WATERVUE

643-651 HUNTER STREET NEWCASTLE NSW 2300

DEVELOPMENT APPLICATION SHEET LIST		
DRAWING NO.	TITLE	REVISION
DA000	PLAN - LOCATION & DRAWING SCHEDULE	F
DA002	SITE ANALYSIS	B
DA003	PREDICT LOCATION PLAN	C
DA005	SITE PLAN	B
DA006	SHADOW DIAGRAMS	B
DA007	SHADOW DIAGRAMS	B
DA008	SHADOW DIAGRAMS	A
DA009	SOLAR ACCESS DIAGRAM	B
DA010	VENTILATION DIAGRAMS	B
DA011	PLANNING - GFA	C
DA012	UNIT AREA FOR CARPARKING GEN.	B
DA101	GROUND FLOOR	E
DA102	PARKING LEVEL 1	D
DA103	PARKING LEVEL 2	C
DA104	PARKING LEVEL 3	C
DA105	PLAN - PODIUM	E
DA106	PLAN - TYPICAL LOWER	D
DA107	PLAN - TYPICAL UPPER	C
DA111	PLAN - PENTHOUSES	B
DA112	ROOF	B
DA200	STREETSCAPE ELEVATIONS	B
DA201	ELEVATIONS - NORTH AND EAST	F
DA202	ELEVATIONS - SOUTH AND WEST	C
DA301	SECTIONS	C
DA321	RAMP SECTION CARPARK	C
DA401	PERSPECTIVE	B
DA402	PERSPECTIVE	B
DA403	PERSPECTIVE	B
DA409	MATERIALS + FINISHES	B
DA801	PODIUM LEVEL PRIVACY SCREENS	A
DA802	SIGNAGE DESIGN INTENT	A

DRAWING No.	DA000
DRAWING TITLE	PLAN - LOCATION & DRAWING SCHEDULE
SCALE	1 : 1 @ A1
DATE	2023

DRAWING No. **DA104**
DRAWING TITLE **PARKING LEVEL 3**
SCALE **1:100 @ A1**
DATE **2022**

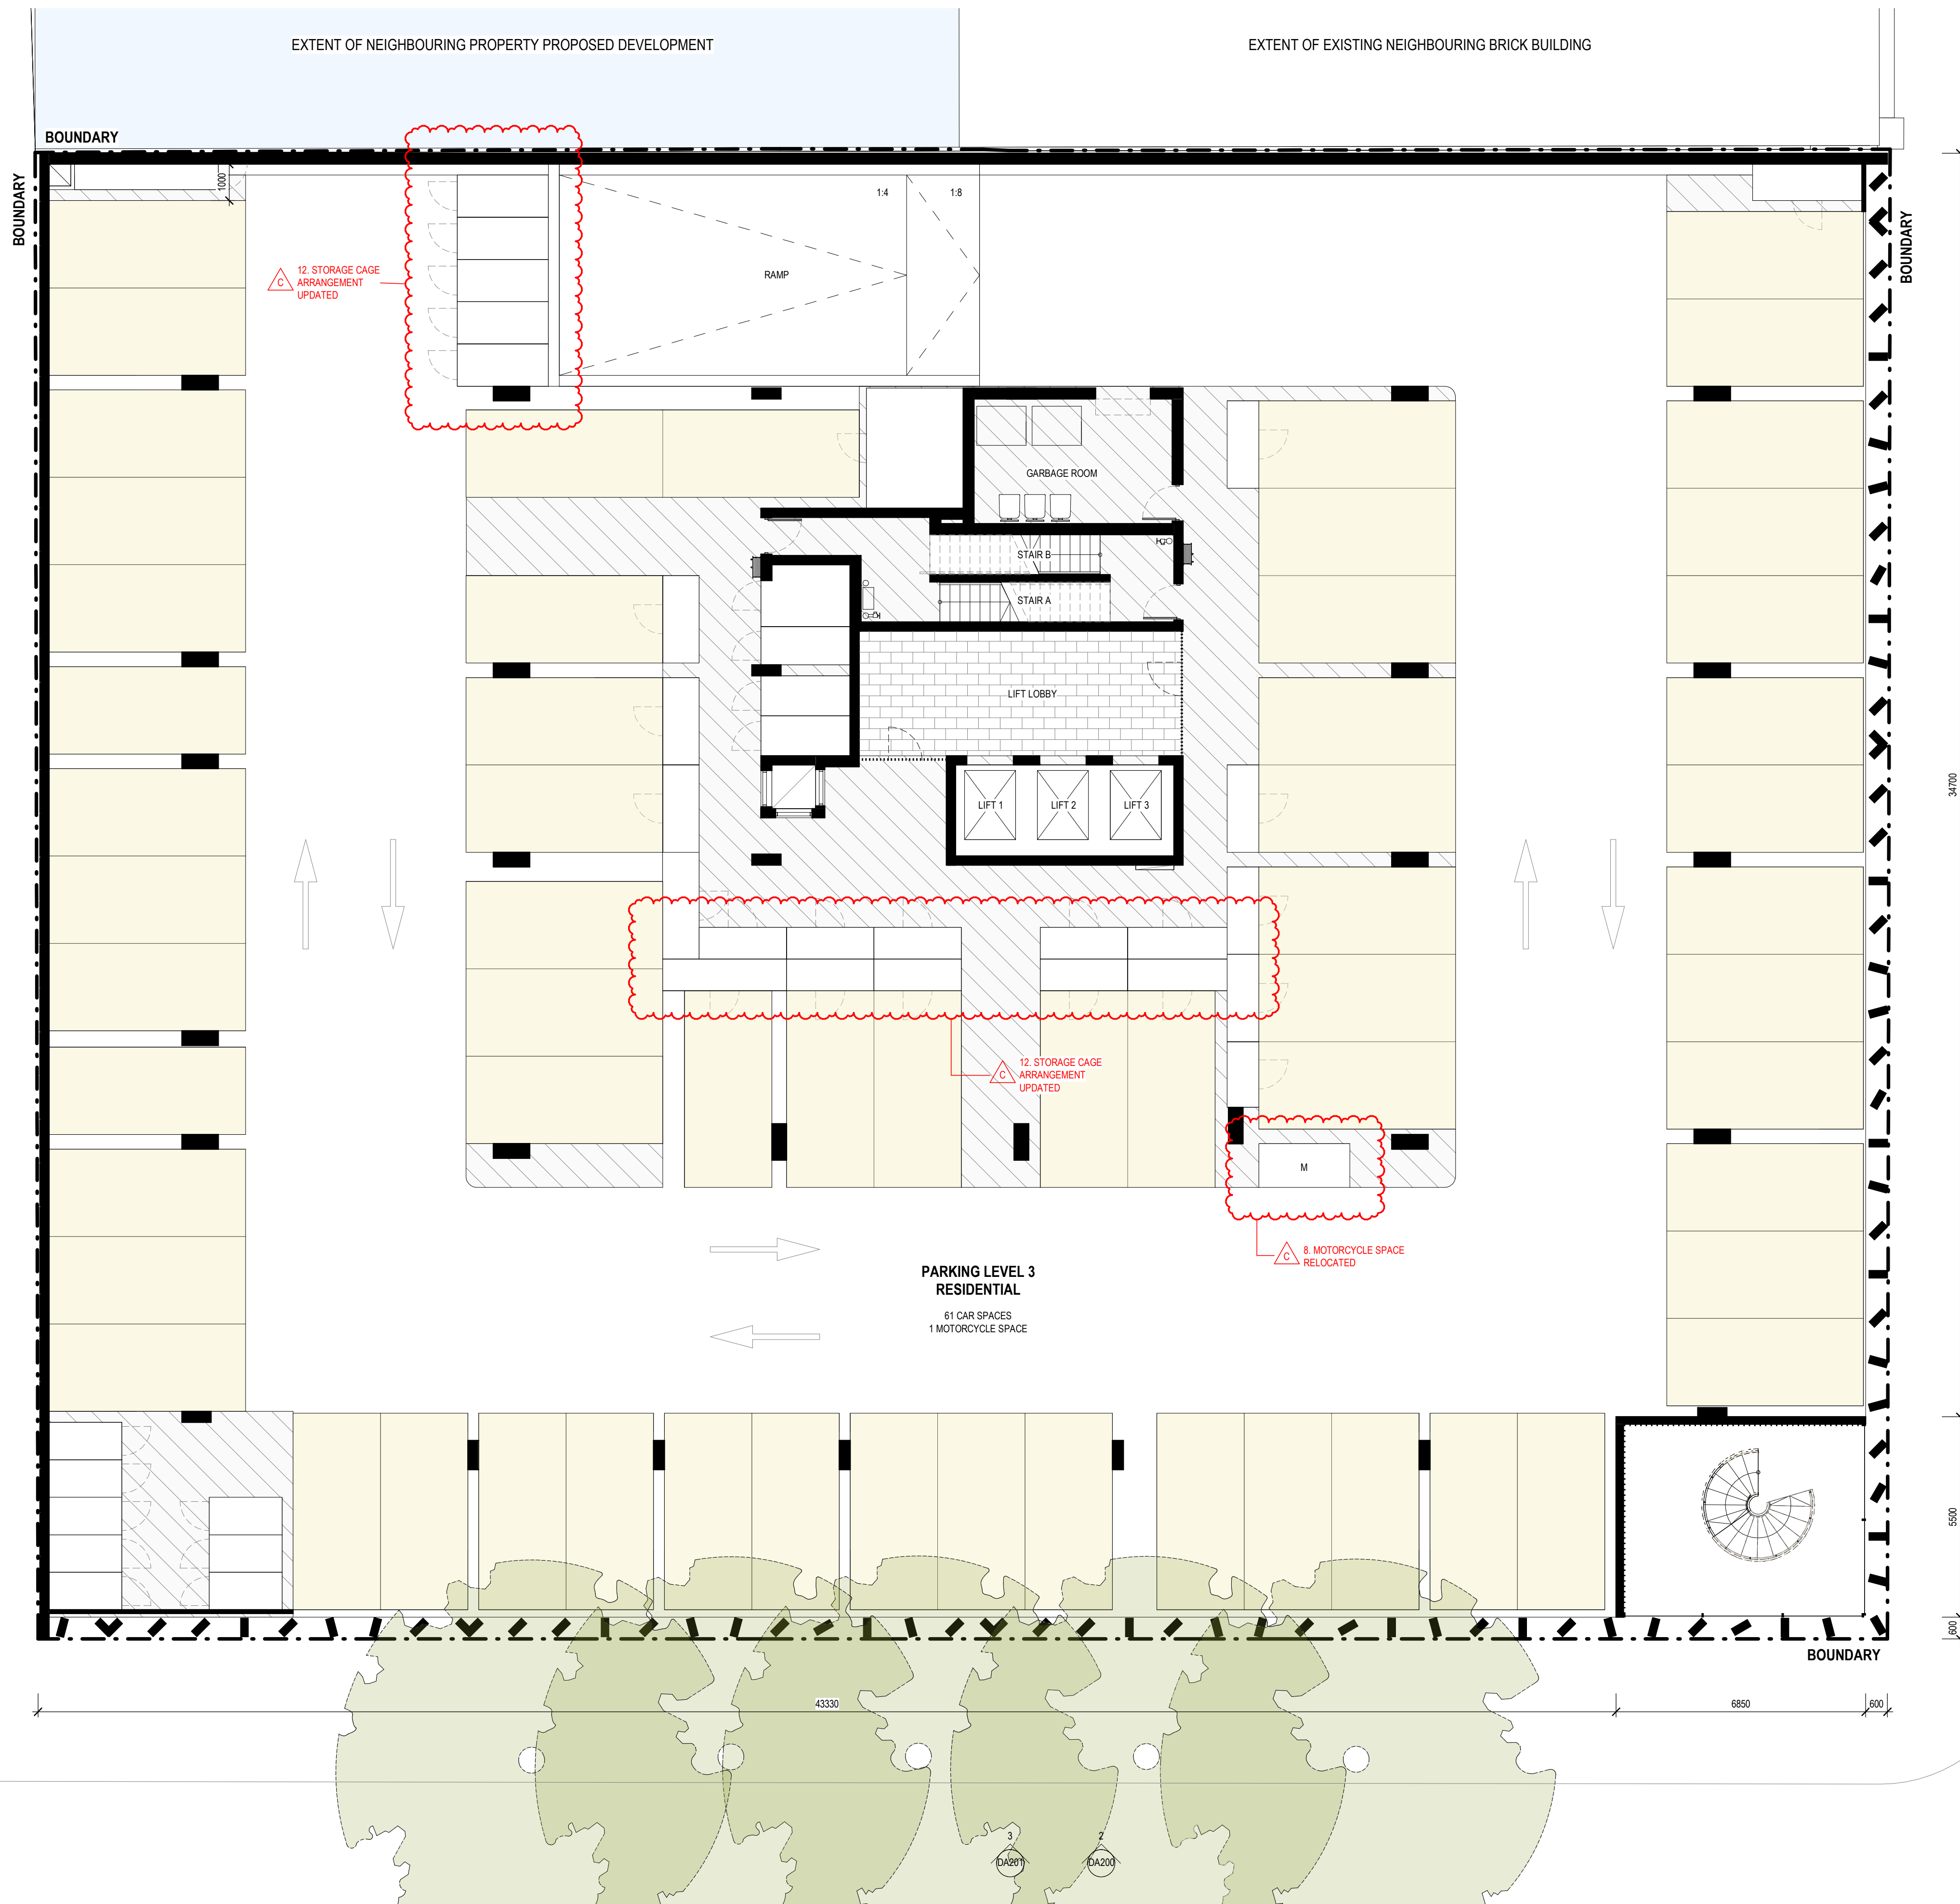
DA RFIS

- GROUND FLOOR CARPARKING LEVEL LOWERED BY 300MM
- DRIVEWAY GRADES UPDATED TO SUIT UPDATED PARKING LEVEL
- DOOR TO FIRE EGRESS CORRIDOR RELOCATED
- STEP ADDED TO FIRE EGRESS PATH TO SUIT UPDATED PARKING LEVEL
- STEPS AND PLATFORM ADDED TO MSB ROOM TO SUIT UPDATED PARKING LEVEL
- MAIL ROOM ADDED TO RESIDENTIAL LOBBY
- MAILBOXES RELOCATED INTO THE RESIDENTIAL LOBBY
- MOTORCYCLE SPACE DISTRIBUTION ACROSS L1, L2 AND L3 UPDATED (TOTAL REMAINS THE SAME)
- SECURE ENTRY ADDED AT BASE OF RESIDENTIAL CARPARK RAMP
- GF TO L1 RAMP LENGTH UPDATED TO SUIT UPDATED GROUND FLOOR PARKING LEVEL
- GARAGE ADDED TO L1 AND L2
- STORAGE CAGE ARRANGEMENT UPDATED
- LANDSCAPE COURTYARD ACCESS DOOR ADDED TO PODIUM LEVEL
- POOL PERGOLA SHOWN IN ELEVATION
